SUBJECT: NuScale Power, LLC Response to NRC Request for Additional Information No. 236 (eRAI No. 9103) on the NuScale Design Certification Application

NuScale Response to NRC Request for Additional Information eRAI No. 9103

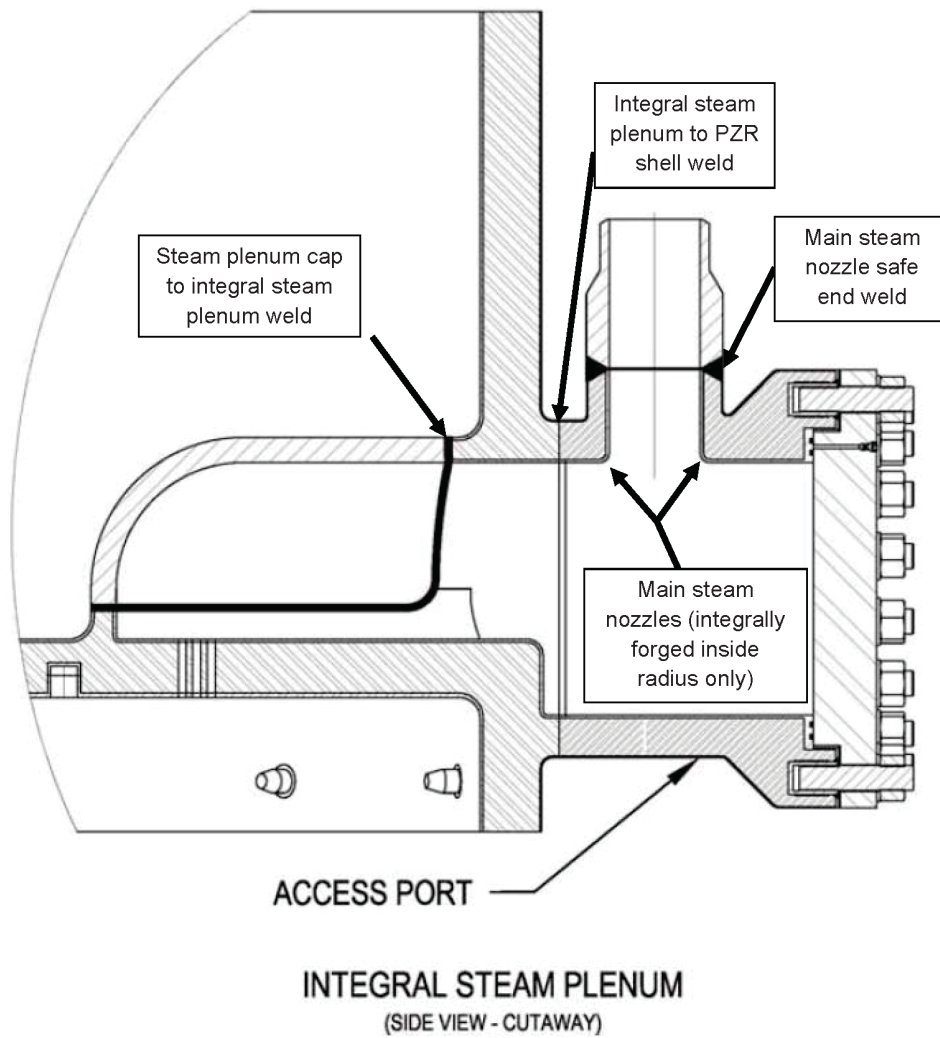
In the DCD, the drawings showing the penetrations through the reactor pressure vessel shell and head appear to show that the nozzles are integral to the shell and head materials (e.g., Figure 5.4-4) and no nozzle-to-shell or nozzle-to-head welds are shown in these figures. Table 5.2-6 describes the nozzle-to-vessel and nozzle-to-head welds as Examination Category B-D, “Full Penetration Welded Nozzles in Vessels.” This is an inconsistency in the two sections of the DCD.

Revise the DCD to resolve this inconsistency, describe how the nozzles are attached to the vessel and head, and provide the proposed ISI requirements for the nozzles so that the staff can confirm that the locations will meet the accessibility for inspection requirements of 10 CFR 50.55a (3)(i).

Reactor pressure vessel head nozzles are integrally forged into the head material. There are no welded nozzles on the reactor vessel head. Examination Category B-D is specified to ensure the inside radii of the forged nozzles are examined as per Figure IWB-2500-7(d) in the ASME BPVC. Nozzles within the reactor vessel shell are welded.

Tier 2, FSAR Table 5.2-6 has been revised (See response to eRAI 9109, RAI 06.06-3) to add the applicable ASME Boiler and Pressure Vessel Code (BPVC) examination requirements. Figure IWB-2500-7(a) through Figure IWB-2500-7(d) in the ASME BPVC identifies the applicable method of nozzle attachment for each nozzle. The appropriate IWB-2500-7(x) figure is added for each nozzle attachment weld in the tables so the appropriate in-service inspection requirements are applied.

For clarity FSAR Figure 5.4-4 has been reproduced below and enhanced to identify the welds by name. Each weld is included in Table 5.2-6 along with the required examination method.
